| B942835 | |
| TRAP LEVER ASSEMBLY | |
| WESTERN ELECTRIC COMPANY, INC. | |

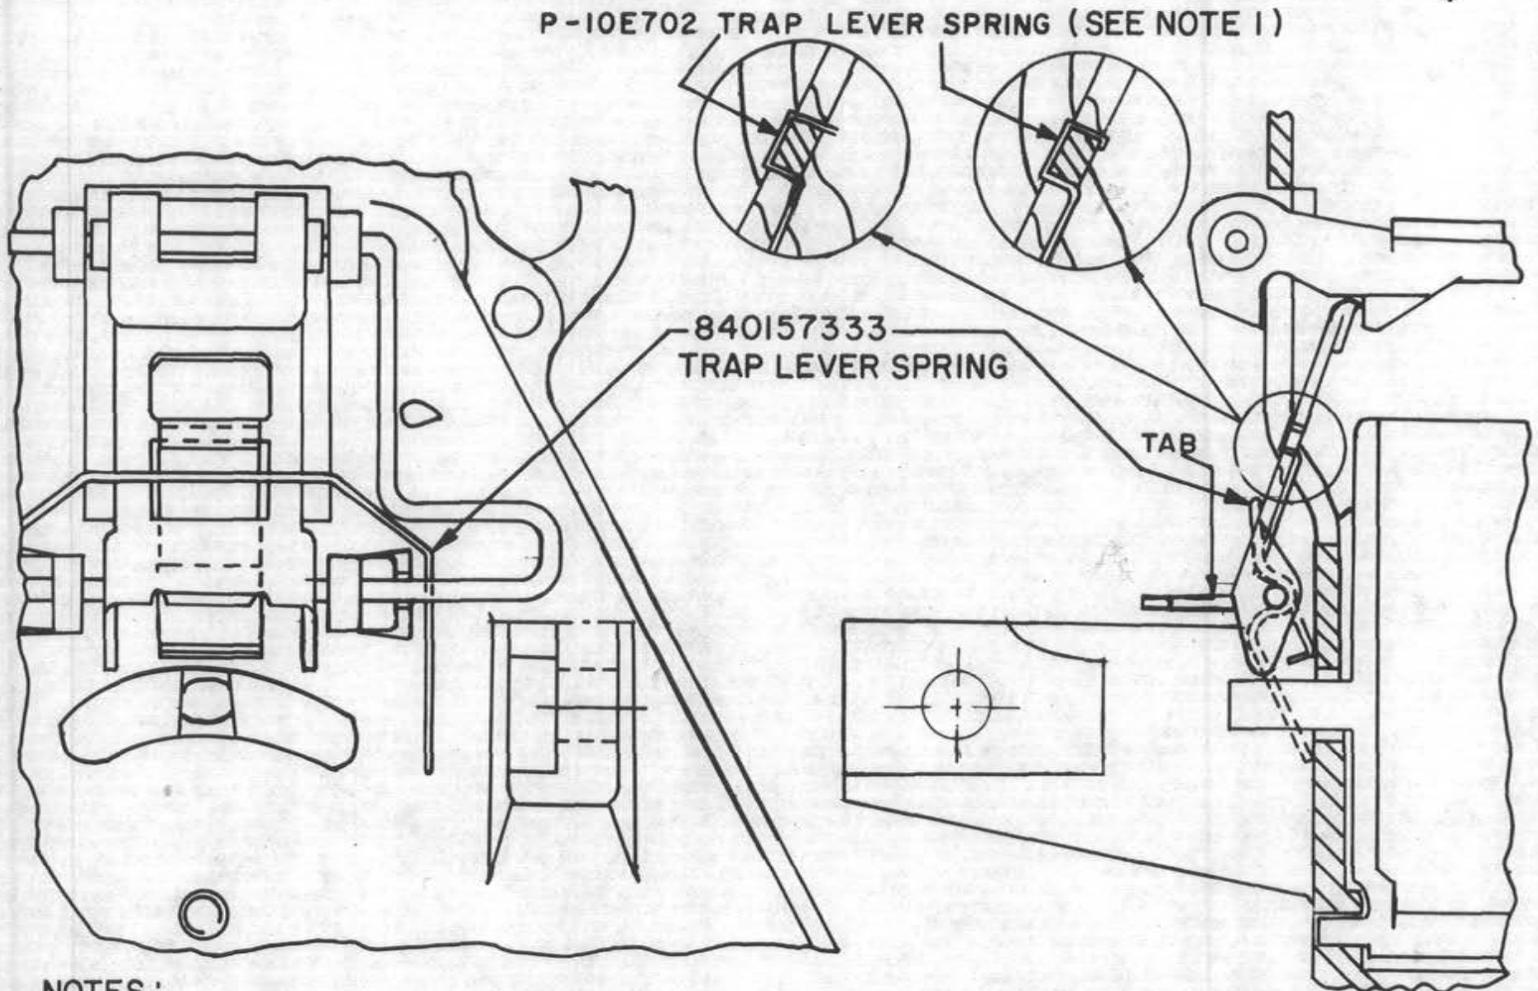
REASON FOR REISSUE:
 TO IDENTIFY TRAP LEVER
 TAB, ILLUSTRATE AND
 SPECIFY A BENDING OF
 THE TRAP LEVER SPRING
 AFTER ASSEMBLY TO TRAP
 LEVER. Title was: Loca-
 tion of Trap Lever Tab.

Reference to trap lever
 tab limit lines removed

TRAP LEVER SPRING
 VIEWS CLARIFIED

CHANGED: PICT TO AGREE
 WITH P-15E717, ISSUE 8
 PER 437779-81C
 FJR
 ISSUE 5
 4-12-76
